Android Ice Axe Leash Component Replacement Notice (February 1, 2002)

"I" OR 4-DIGIT DATE CODE ON LEASH TAB (XXXX)

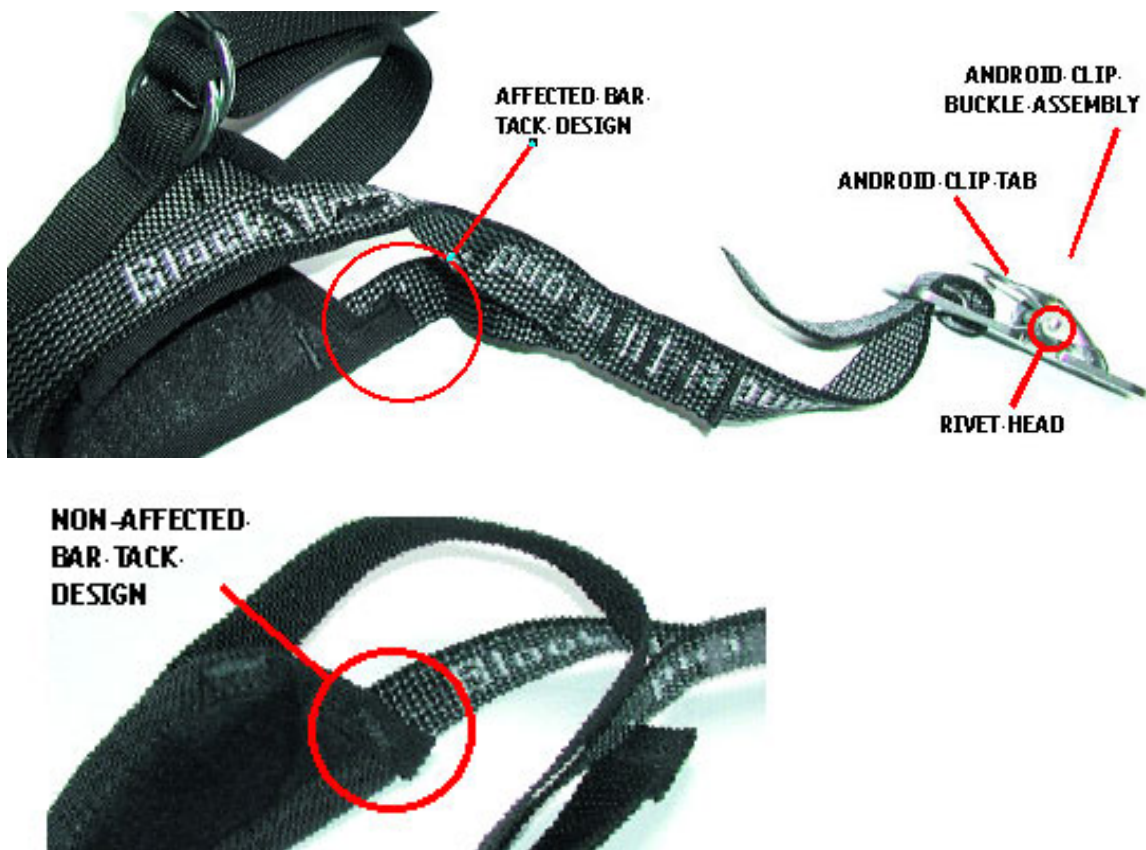
A small percentage of Androids manufactured this season are affected by this notification. Leashes manufactured between 4/02/01 and 1/18/02 need to be replaced, and can be identified by the cuff design in conjunction with markings on the Android Clip Buckle. THESE LEASHES SHOULD NOT BE USED.

Androids shipped during this time may be prone to the Android Clip Tab moving past the rivet. The clip tab may move past the rivet head and prevent the Android Clip from properly closing and opening. If you have an Android that meets this criteria, please contact your local Black Diamond Dealer, the location where you purchased the Android, or the Black Diamond Warranty department for a replacement component. Replace the Android Clip Assembly and thread the webbing as shown.

Products manufactured and shipped since 1/19/02 continue to use this cuff design but can be identified by an "I" on the bottom of the leash tab or a 4-digit date code on leash tab and do not need to have the Android Clip replaced.
